## Planning and Zoning Commission - Special Meeting AGENDA

- 6.** ACTION ITEM: Recommendation to hold a public hearing and take action on the Crossbuck McNeen Townhome Design Review (File No. P21-025) and Townhome Subdivision Preliminary Plat (File No. P21-026) applications for the development of two new detached townhome units on an undeveloped property located at the southwest corner of 2nd Avenue and W 7th Street (Ketchum Townsite: Amended Block 67: Lot 1A) within the City's General Residential Low Density (GR-L) Zoning District. The public hearing for this project has been continued from the Planning & Zoning Commission Meetings of July 27th and 30th, 2021.

**Exhibit A:**  
**Crossbuck McNee Townhomes**  
**Updated Project Plans**

## CROSSBUCK TOWNHOMES II

Sheet No:  
L1.0

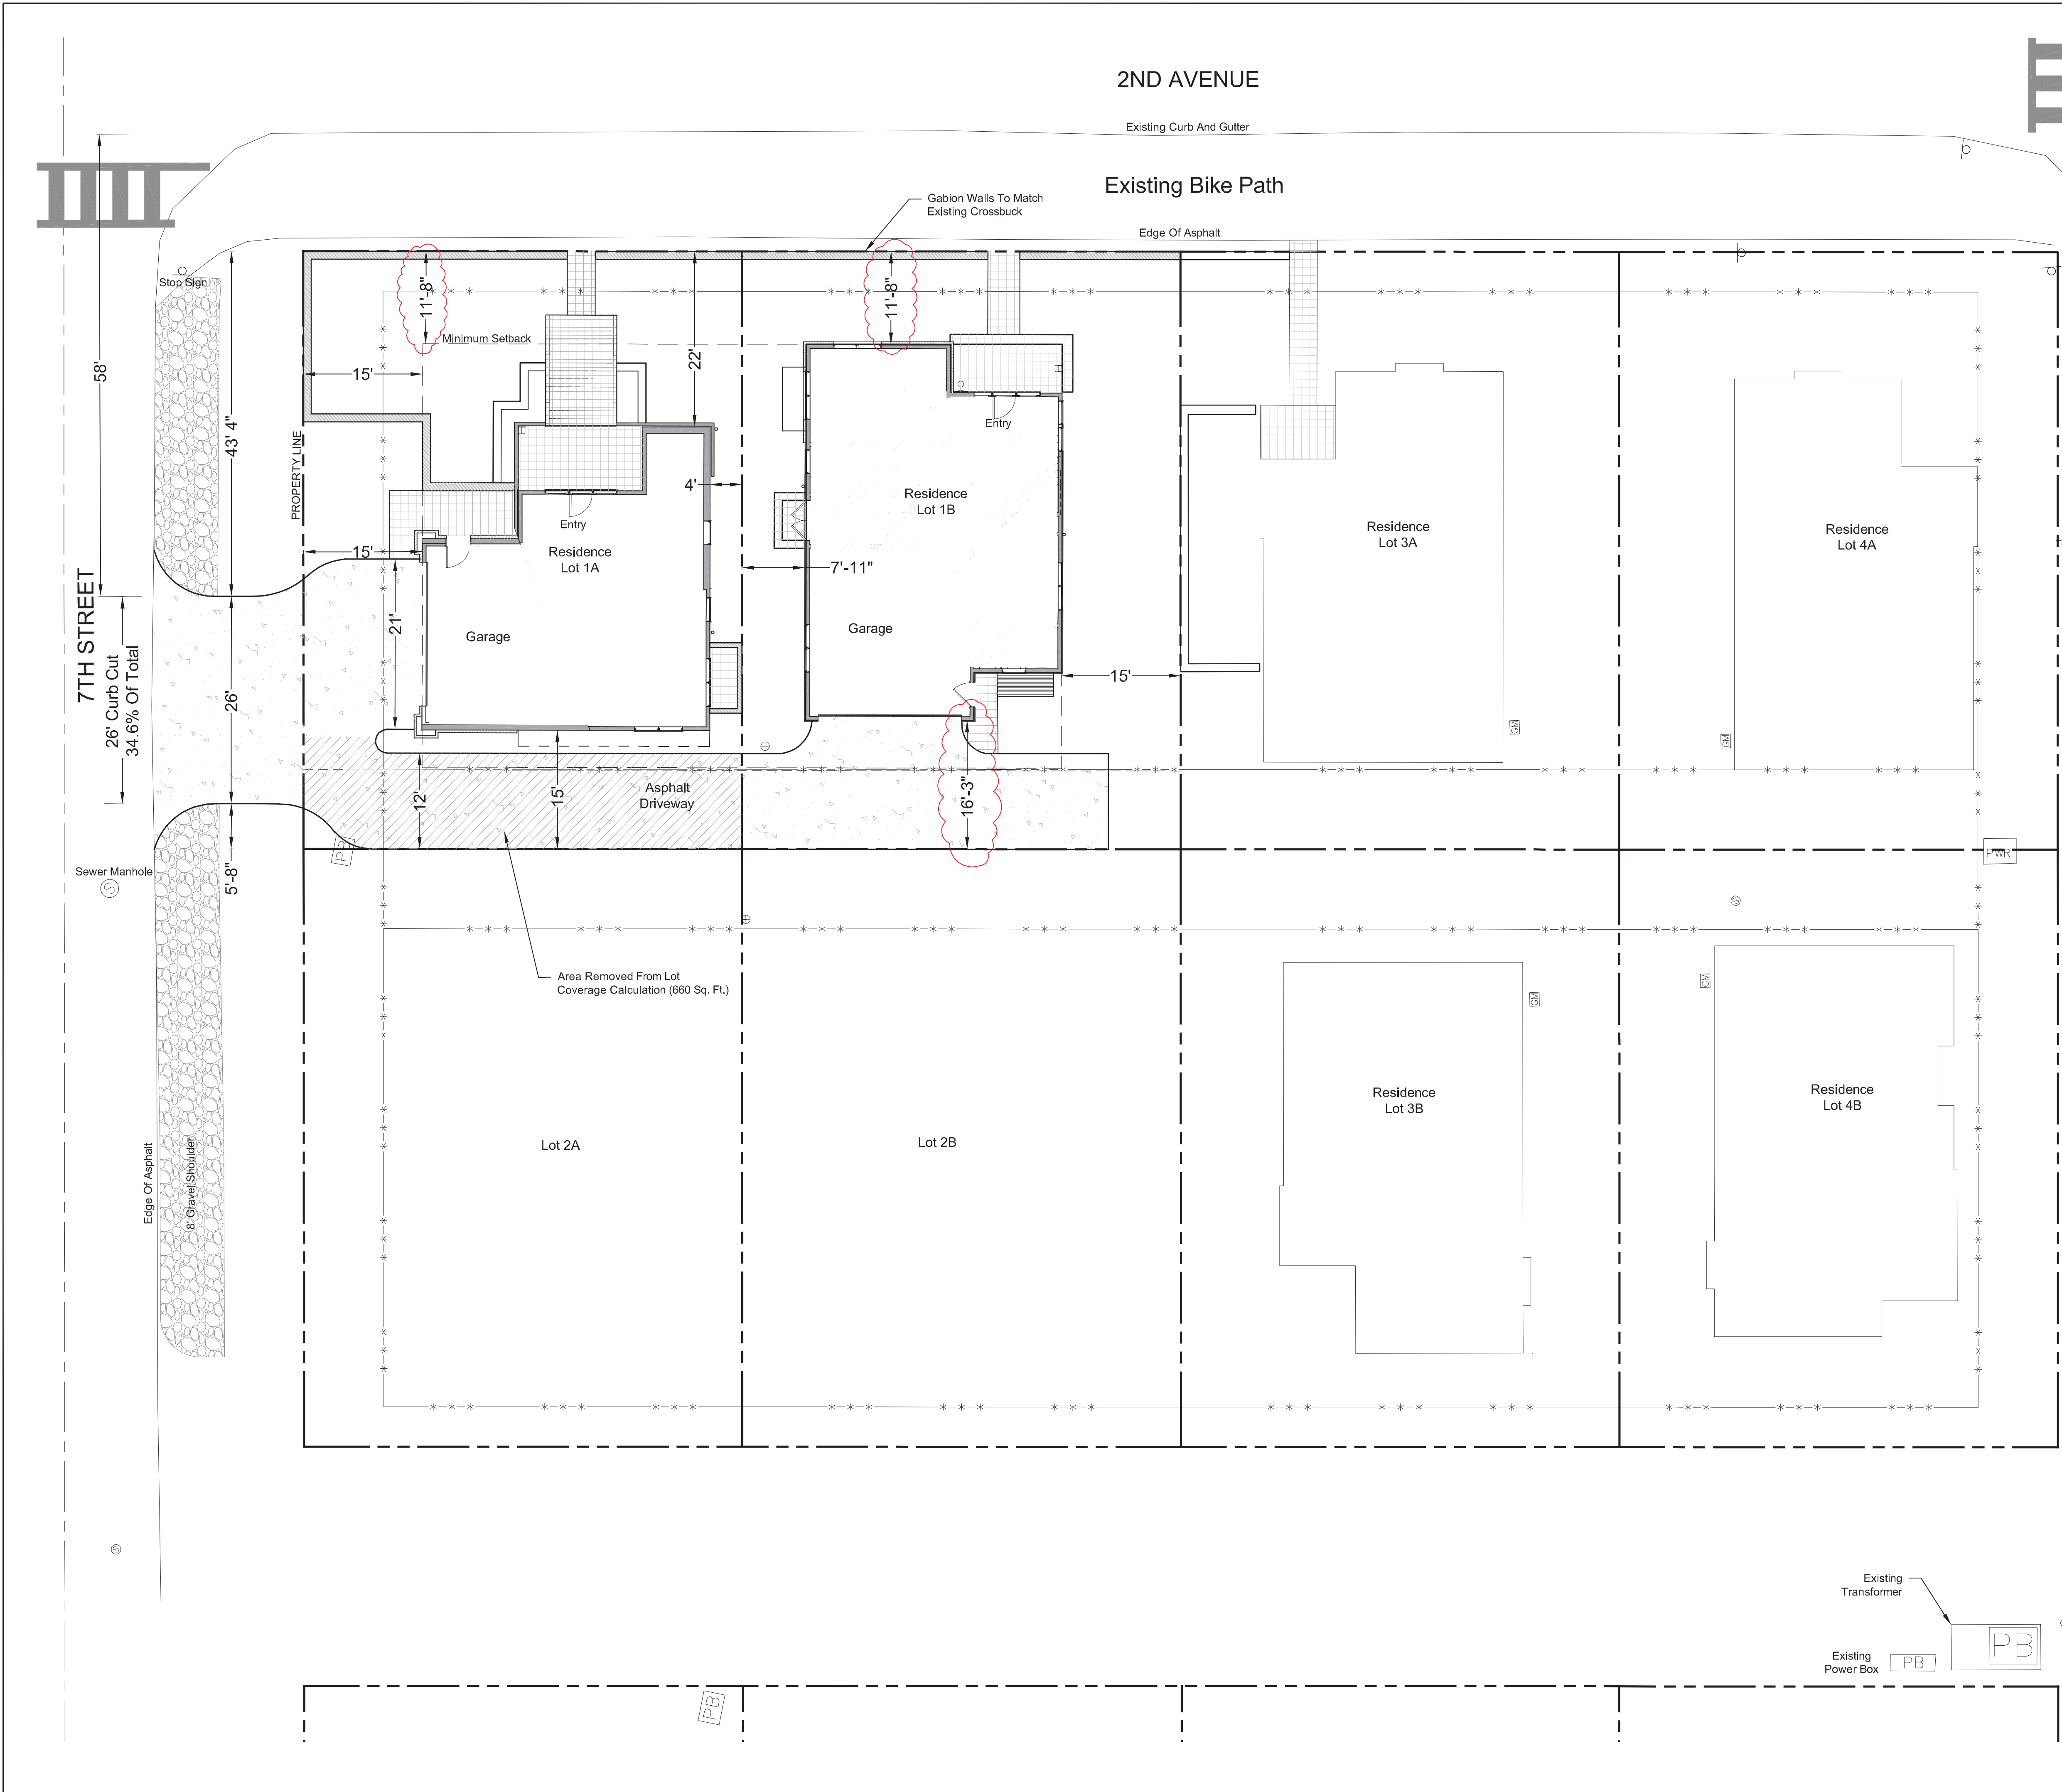
The site plan on Sheet L1.0 shows three stairs encroach within unit A's required setback from 2<sup>nd</sup> Avenue. These stairs are not permitted within the required side setback area.

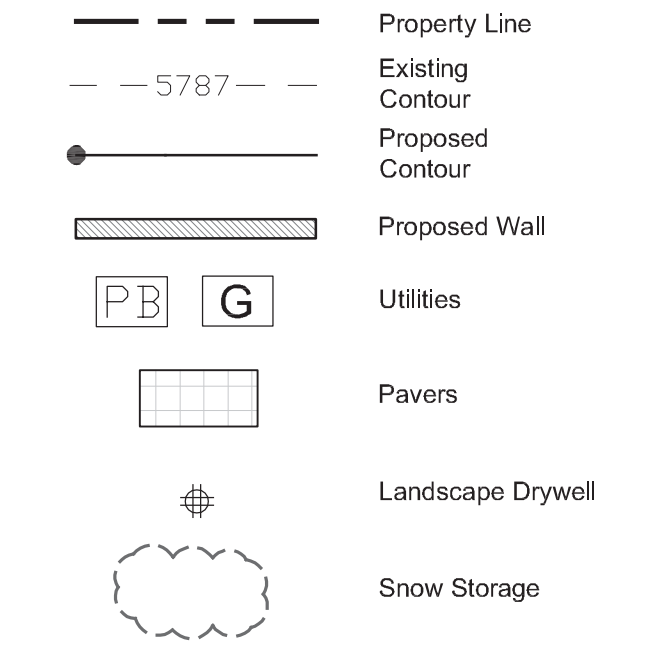
<b>Staff Comments</b>	The snow storage calculation is indicated on Sheet L3 of the property plans. The applicant has provided 600 square feet of snow storage on site, which is 30% of the asphalt driveway area.
<input checked="" type="checkbox"/>	<input type="checkbox"/>	<input type="checkbox"/>	<b>17.96.060.H3 Snow Storage</b>	<b>A designated snow storage area shall not have any dimension less than five (5') feet and shall be a minimum of twenty-five (25) square feet.</b>
			<b>Staff Comments</b>	The 3 snow storage areas meet this dimensional requirement. The snow storage areas provided on site are 200, 50, and 350 square feet.
<input type="checkbox"/>	<input type="checkbox"/>	<input checked="" type="checkbox"/>	<b>17.96.060.H4 Snow Storage</b>	<b>In lieu of providing snow storage areas, snow melt and hauling of snow may be allowed.</b>
			<b>Staff Comments</b>	The applicant has provided snow storage on site.

<b>Staff Comments</b>	The landscape plan is provided on Sheet L3 of the project plans. Landscaping includes conifer trees, flowering crab deciduous trees, deciduous shrubs, and grasses. The landscape plan shows 7 deciduous trees planted along the street frontages. The proposed landscaping will beautify the adjacent bike path.
<input checked="" type="checkbox"/>	<input type="checkbox"/>	<input type="checkbox"/>	<b>17.96.060.I3 Landscaping</b>	<b>All trees, shrubs, grasses and perennials shall be drought tolerant. Native species are recommended but not required.</b>
			<b>Staff Comments</b>	All proposed landscape materials and vegetation types shall be drought tolerant. The applicant is encouraged to select native species.
<input checked="" type="checkbox"/>	<input type="checkbox"/>	<input type="checkbox"/>	<b>17.96.060.I4 Landscaping</b>	<b>Landscaping shall provide a substantial buffer between land uses, including, but not limited to, structures, streets and parking lots. The development of landscaped public courtyards, including trees and shrubs where appropriate, shall be encouraged.</b>
